ORDER UNDER SECTION 96 (2) OF ACT, III OF 1901.

Re: Plot No. 18, F-10 Civil Lines Quarter.

PROPOSED EXTENSION

ON PLOT NO 18 SHEET NO F.10

PLAN OF UPPER FLOOR

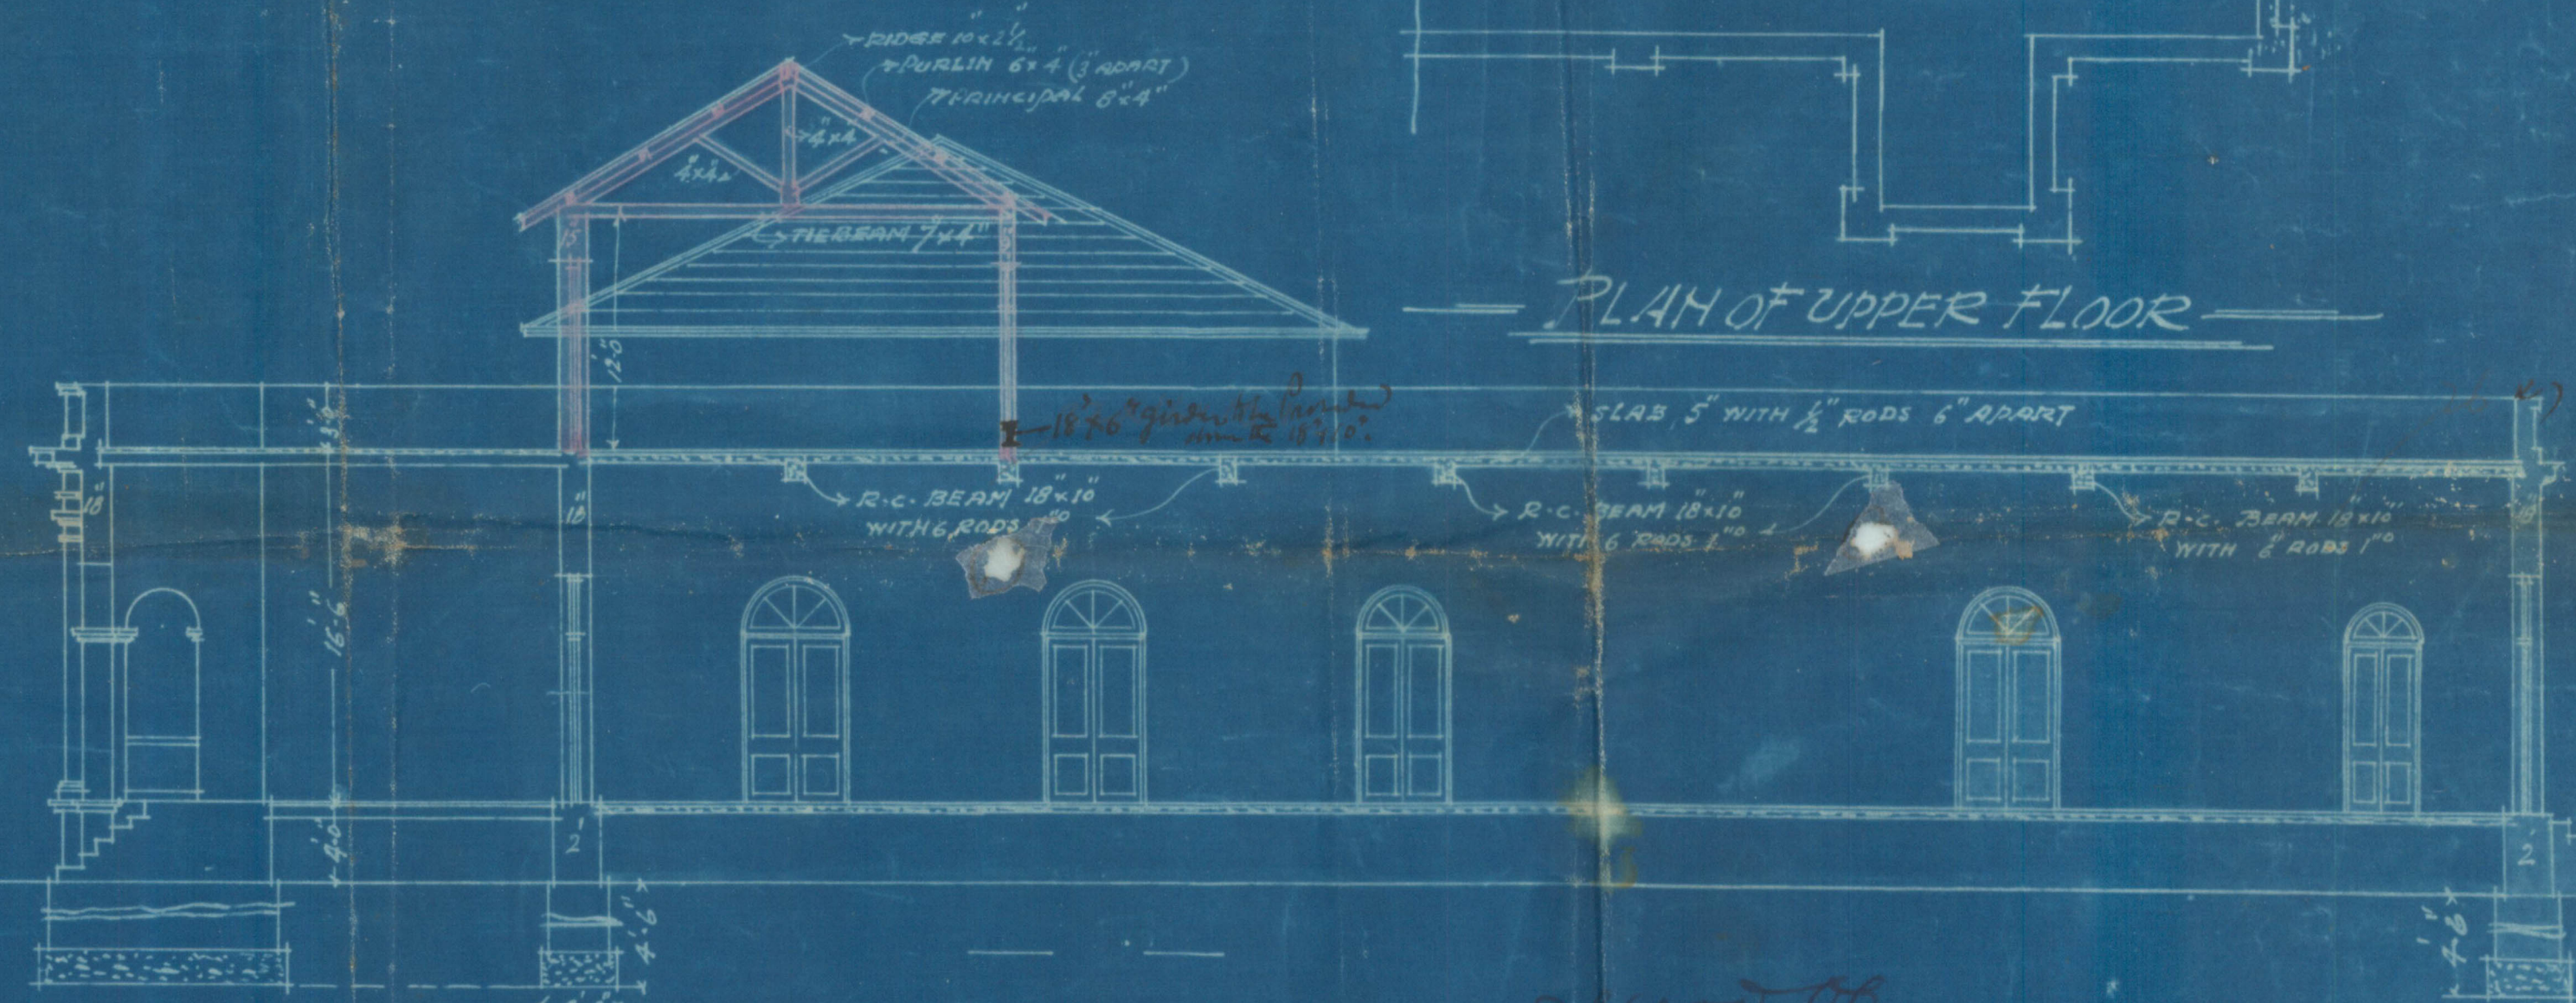
With reference to his application dated 28th ultimo with a plan for additions & alterations to the Karachi Club Dr. Shroff the Honorary Secretary of the Club is informed that the plans are being sent to the Managing Committee for sanction on the condition that a steel beam 18" x 6" be provided below the 9" wall of 1st floor room as the R.C. beam 18"x10" is not strong enough to carry the weight of the said wall.

If the beam 18×10 is not inside then the floor
 plan also may be included & the total B.M.
 be found out.

SECTION ON A-B

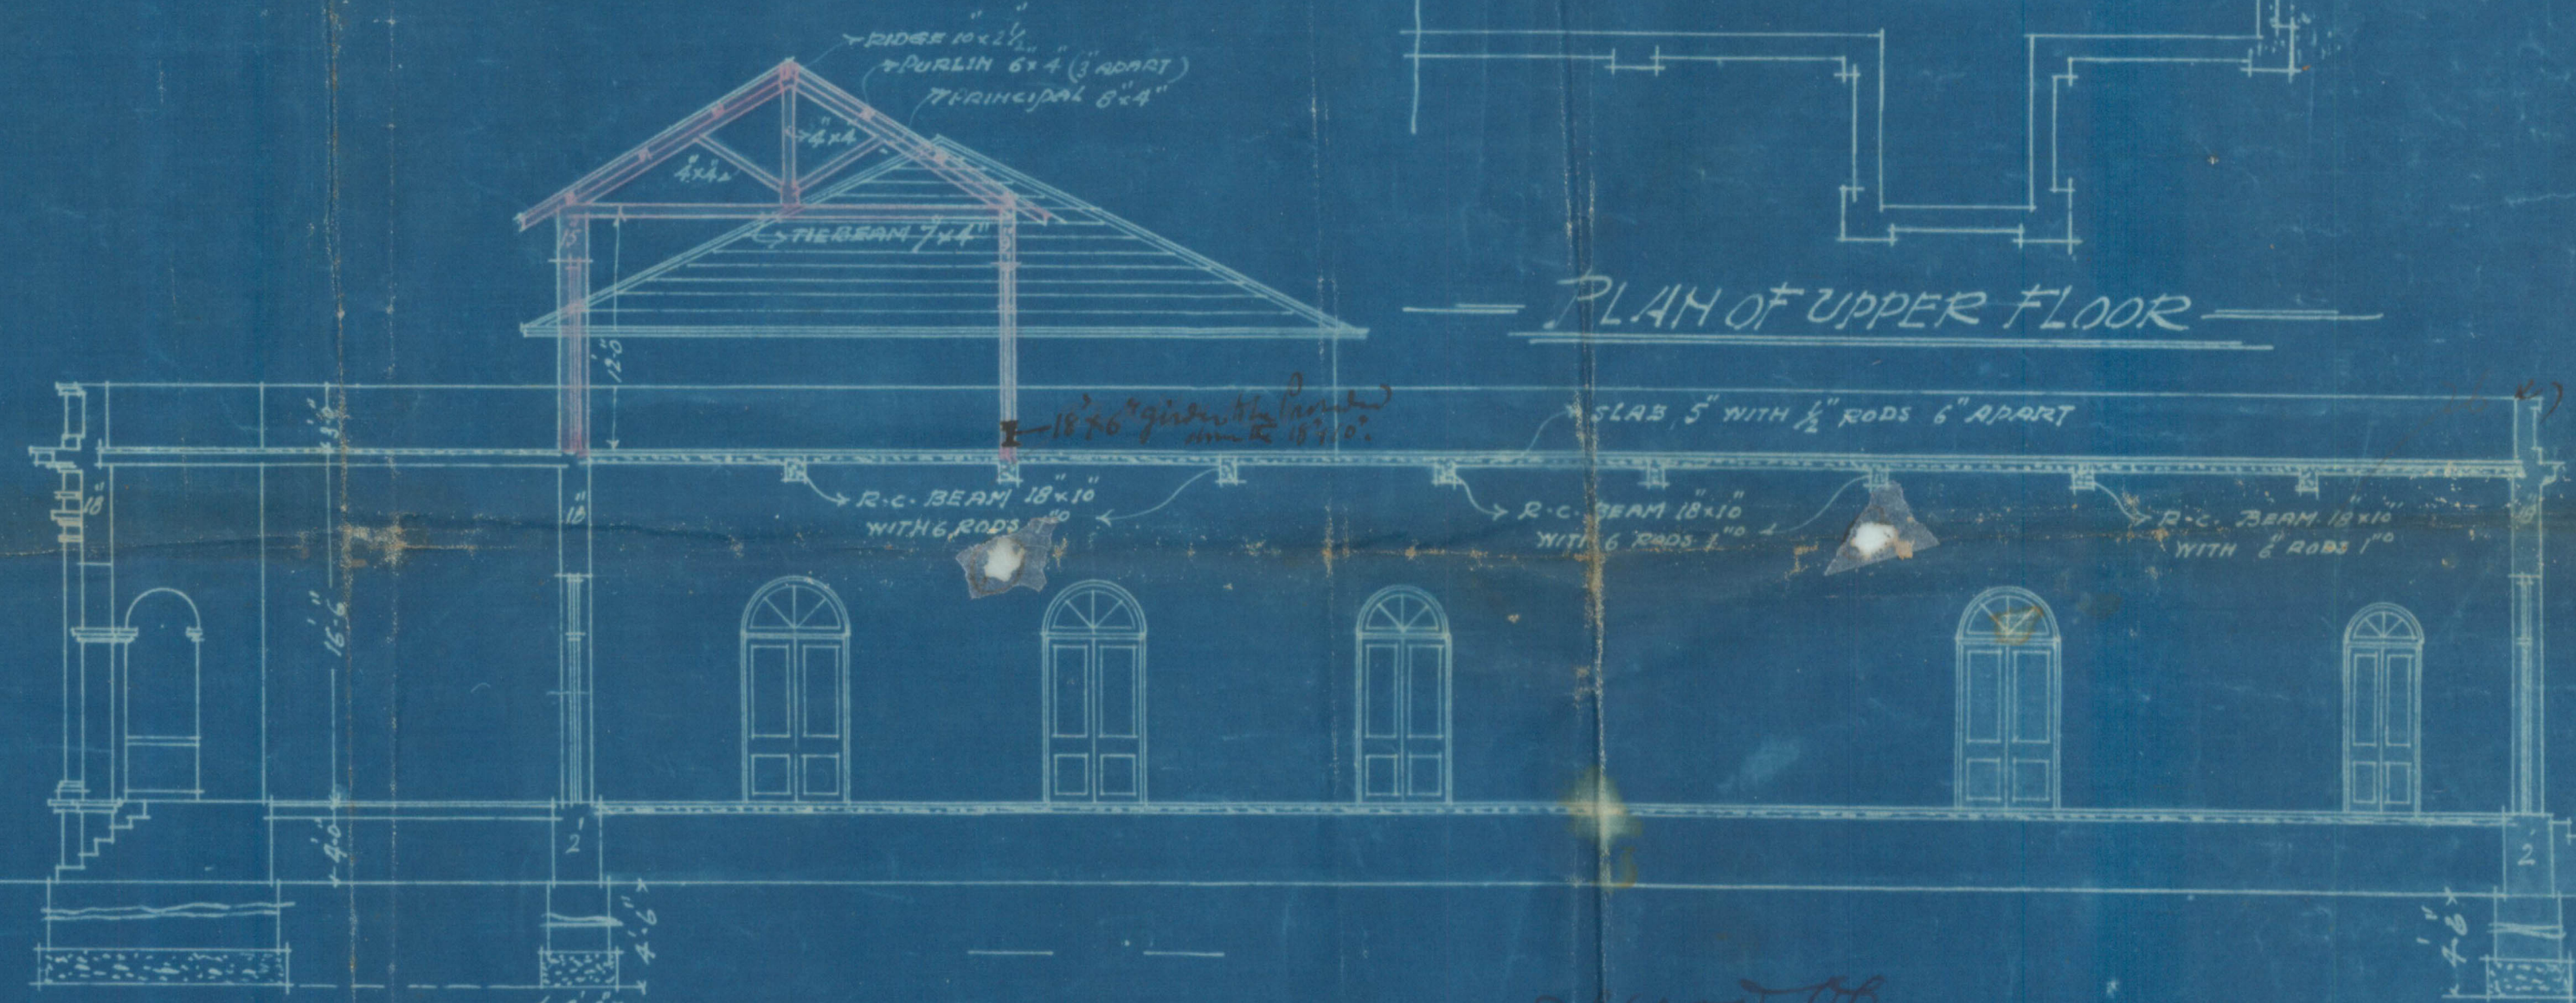
My Age,
 Please calculate the load on the beam -
 Prints with the tank at 120 lb/cu ft.
 Wind & roof load 50 lb/sq ft
 Deduct door & window openings.

Is the building built as per former drafts of
 gr. floor only? If yes they will have to provide
 another beam to take the above load only.

The Calculations are here with
 Attaches, but a chief beam is to
 be checked of Bay window over which
 the two beams are resting.

The Architect has not shown its
 section or reinforcement, but it is the same
 size as others on site, how it can
 be checked without turning steel area
 over. The roof has been completed.

Here the beam is weak.

It should be 32×16 with 10 rods 1" dia.

1. The size of beam shown in 26 x 10 inches of 78 x 10 with 006, 1" dia
2. The size of beam below Ceiling P. was must be 32 x 16, 10 Rad 1" di.

The Plan may be
 approved & the Doctor's
 alterations drawn & approved
 a steel beam 18×10 below
 the 9' wall. The rest is
 alright

then for the size of sea shall be 26×10
 inch 7 inch 1" dia.
